| **Climate control** | Compressor 699357 | Modification pulley | VAG models

Compressor safe guard modified

The breakaway device of the pulley has been improved

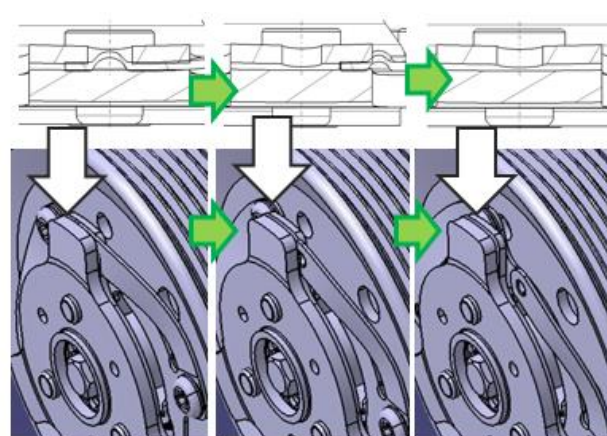
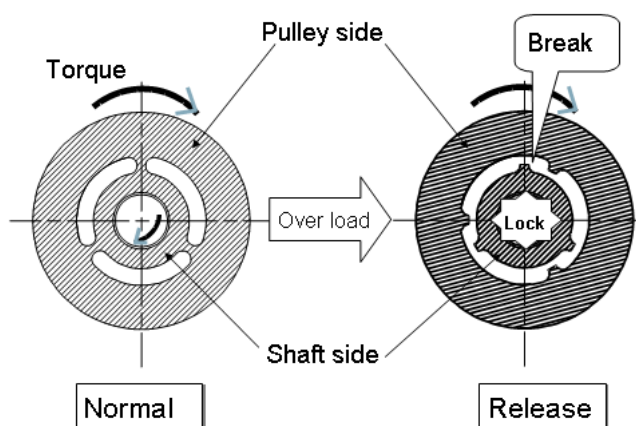
The solution has been found in using a different pulley / damper assembly; formerly this was a "clutchless" type, where it is now a "driver" type.

The differences are as follows:

Old configuration:

- Plastic pulley assembly
- Rubber damper assembly
- Robustness with regard to negative torque about 1,000,000 cycles (20 Hz, 25 ± 35 Nm)

New configuration:

- Metal pulley assembly
 - Steel "driver" composition
 - Robustness with regard to negative torque about 10,000,000 cycles (20 Hz, 25 ± 35 Nm)
- 10x more!**

- Decoupling through breakage

- Mechanical decoupling
